Video Products
Service Bulletin

Model: SLV-353UC/555UC/757UC

No. 98

Subject: Emergency Shut-Off During
Playback/Review Mode

CIRCUIT DIAGRAM

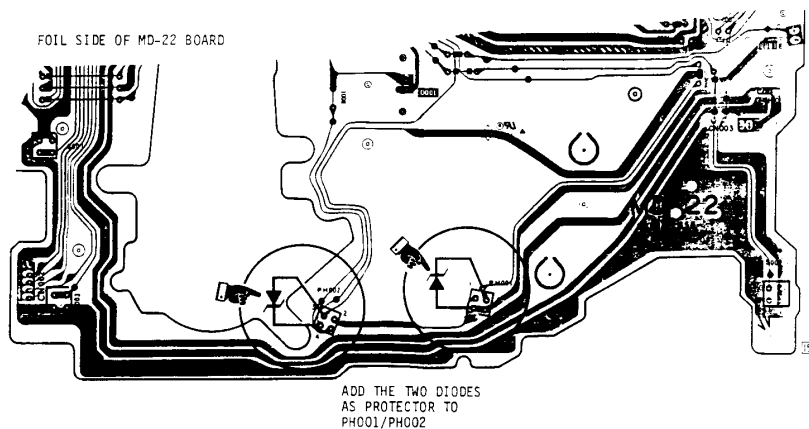
The unit goes into emergency shut-off during the Playback/Review Mode and does not accept any function key commands.

Solution: Replace PH001 and PH002 on the "MD-22" Board and add two diodes to the foil side of the circuit as shown in the following diagram.

Ref. No.	Description	Part Number
PH001	IC PS6002	8-759-144-33
PH002		
---	Diode RD-6.2ESB2	8-719-109-93
